PLAN OF PROPOSED IMPROVEMENT

124TH STREET TO 91ST STREET

STH 100

STATE PROJECT NUMBER
2150-05-70

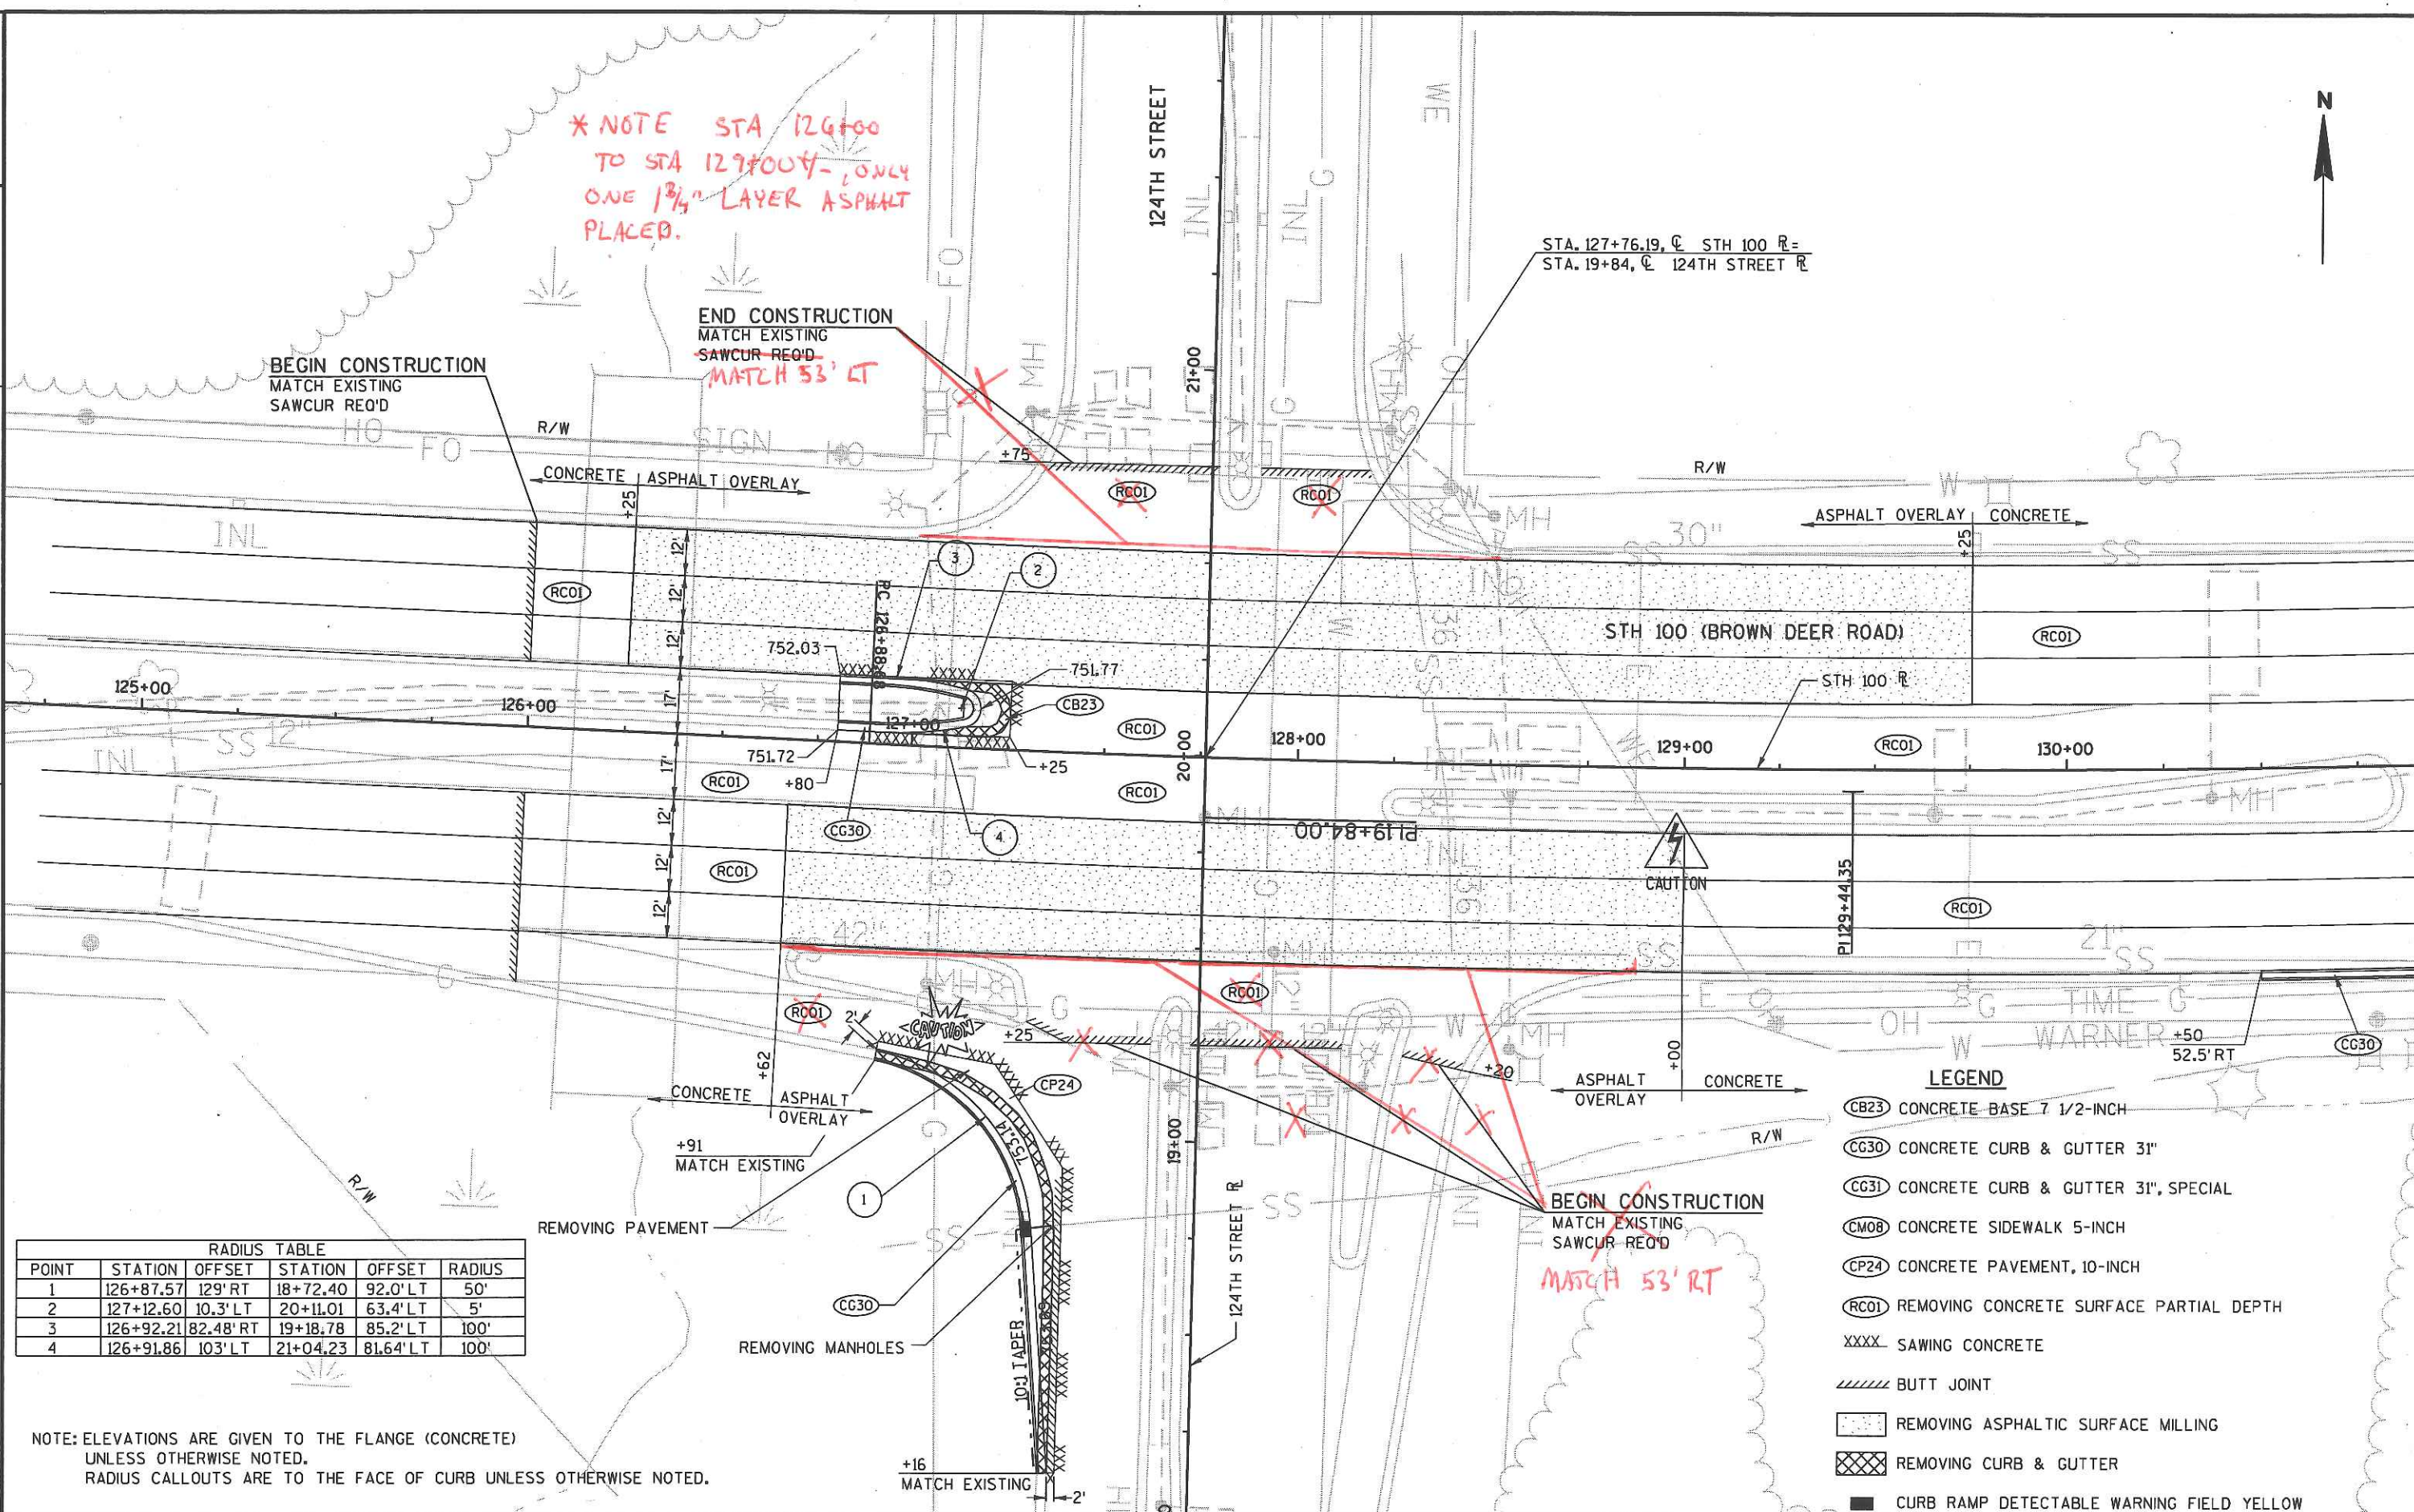
* NOTE STA 126+00
TO STA 129+00 - ONLY
ONE 1 3/4" LAYER ASPHALT
PLACED.

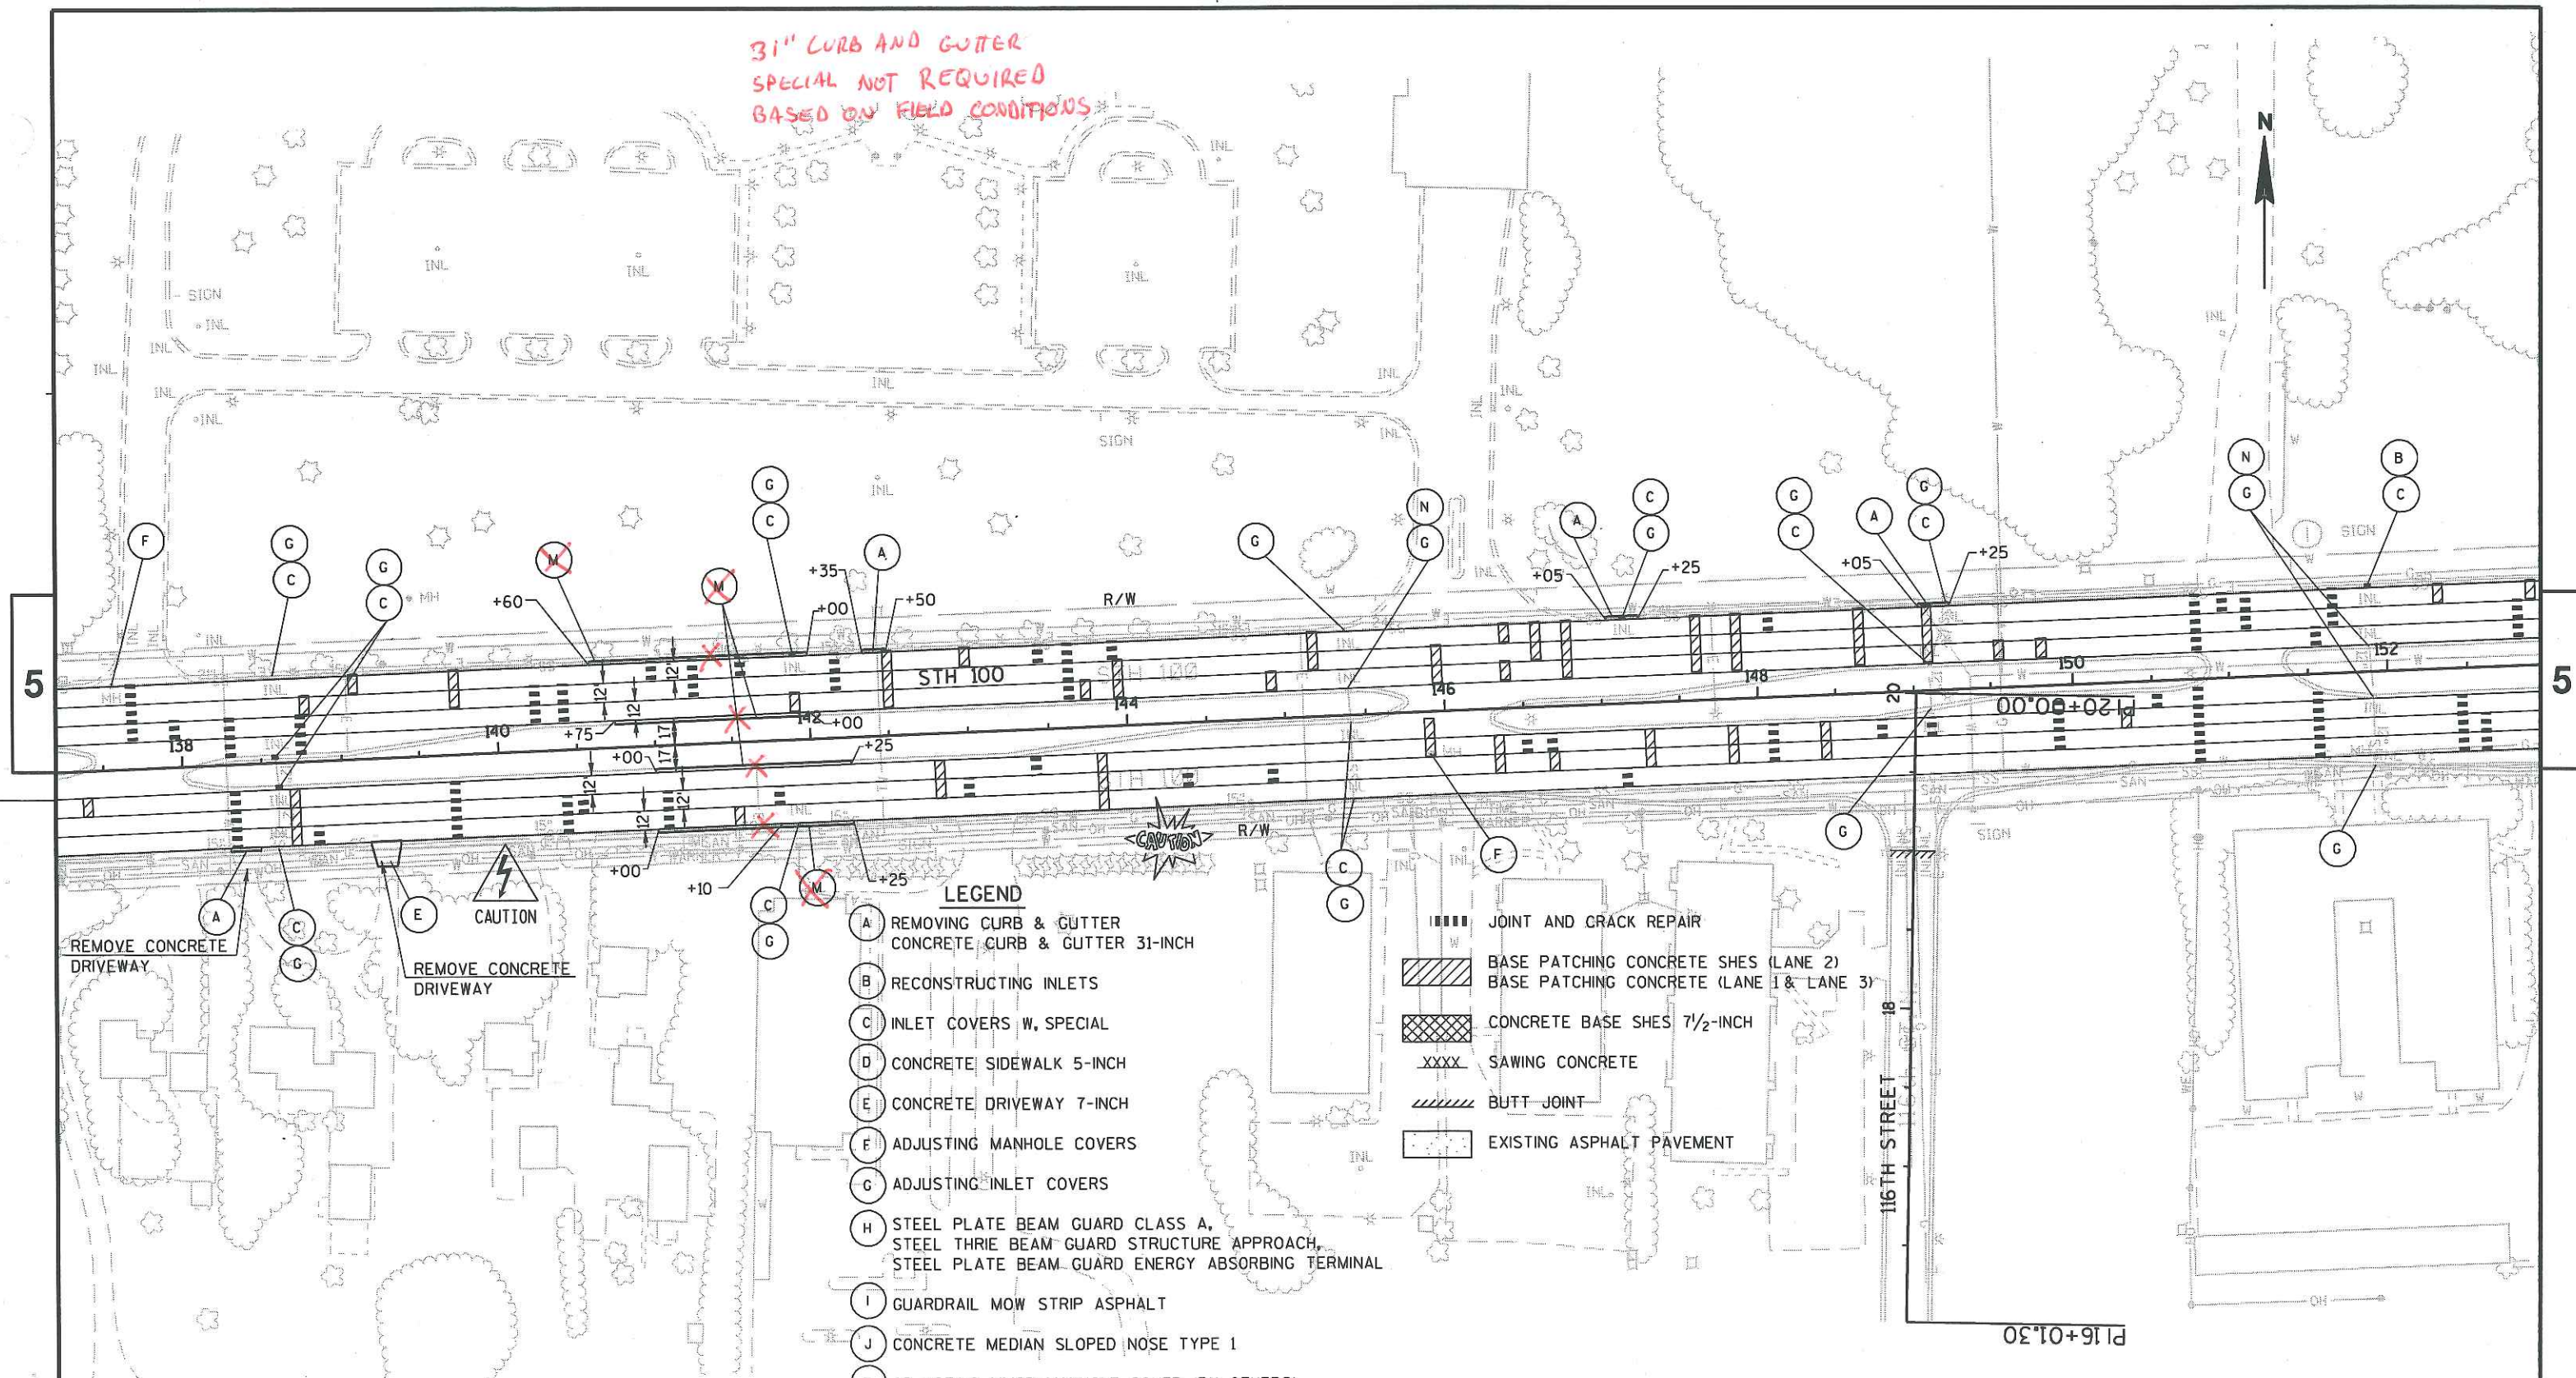
31" CURB AND GUTTER
SPECIAL NOT REQUIRED
BASED ON FIELD CONDITIONS

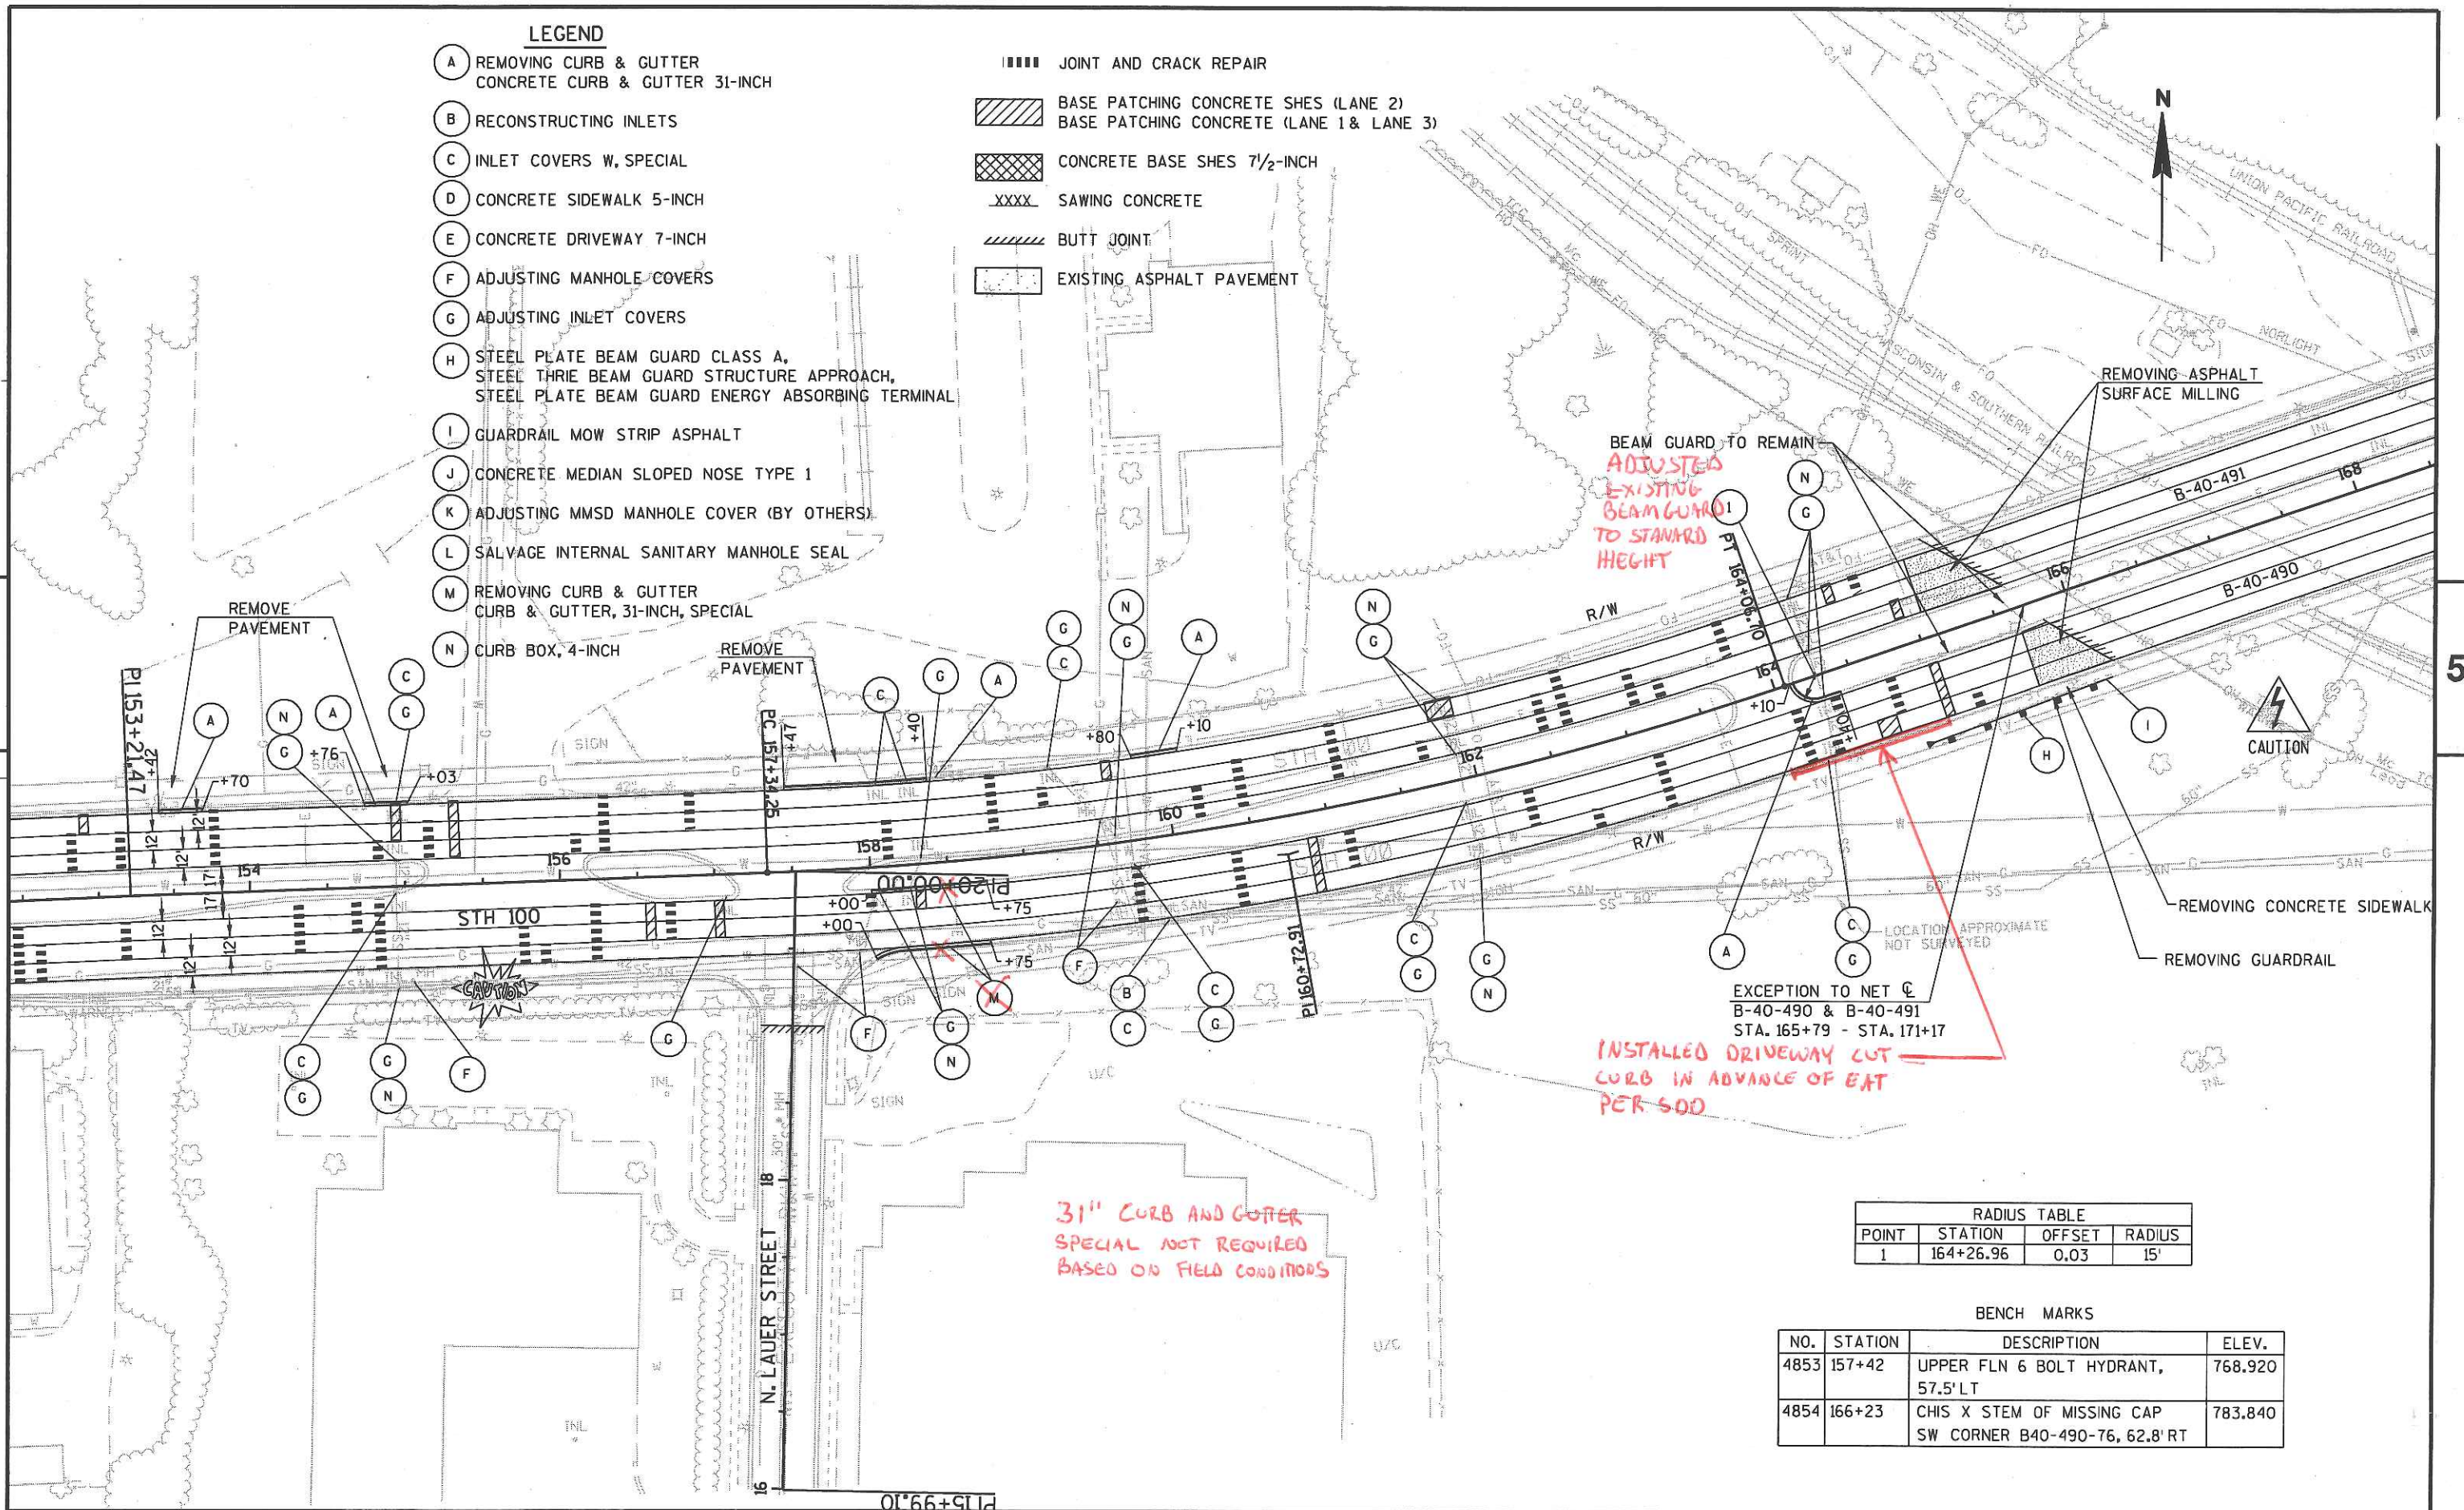
31" CURB AND GUTTER
SPECIAL NOT REQUIRED
BASED ON FIELD CONDITIONS

EXCEPTION TO NET C
B-40-490 & B-40-491
STA. 165+79 - STA. 171+17
INSTALLED DRIVEWAY CUT
CURB IN ADVANCE OF EAT
PER SDD
